# The St Leonards and Crows Nest Station Planned Precinct

## GCA SUBMISSION ON PEDESTRIAN AND BICYCLE PATHS

*An outline of the proposed new paths and River Road crossings (shown in larger format in **Attachment A** at the end of this submission)*

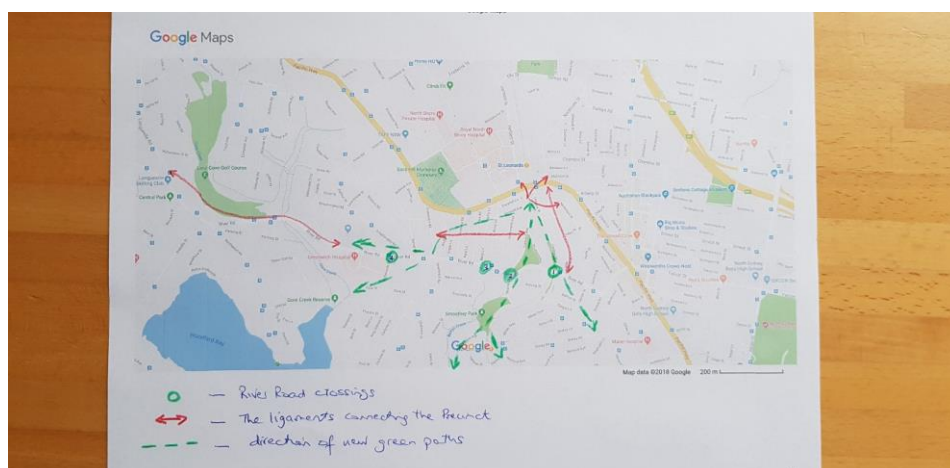
- River Road is currently dangerous and virtually impassable – green pathways across River Road need to be created for pedestrians and bicycles (1) at the River Road railway bridge, (2) at Canberra Avenue, (3) at Wilona Avenue/Eastview Street, and (4) at St Vincents Road –and they must be safe and separated from traffic; traffic islands are not safe, the crossings need to be underpasses (eg at the railway bridge) or overpasses,
- an East-West path is needed between Greenwich Road (between Pacific Highway and River Road) and Oxley Street/Nicholson Street,
- a safe path is needed from Greenwich Public School through or beside the Lane Cove Golf Course to Lane Cove shops,
- to the North, the connection from Canberra Avenue/Marshall Avenue to Herbert St needs to be improved – a tunnel passage under Pacific Highway could be a good solution here.

*Greenwich Road "bicycle" lane – this is not safe – a real bike path must be separated from traffic as in the photo on the next page below*

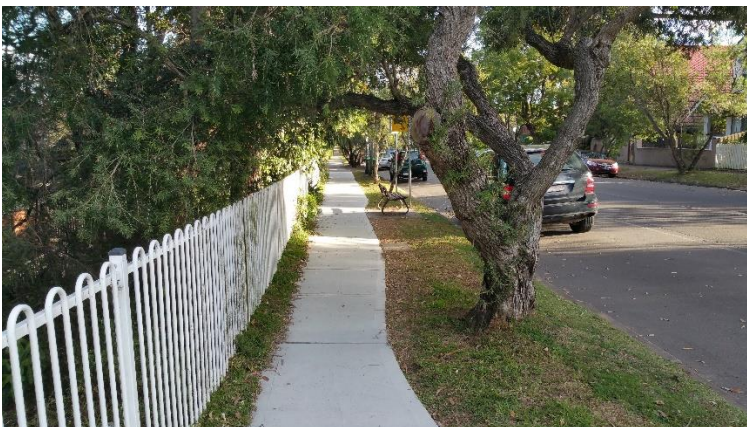
It is not good enough, for example, to paint a line on the road where cars park and add an occasional painted bicycle icon, as in Greenwich Road (see below). That is not separated or safe. It is not an effective part of an integrated system of bike paths.
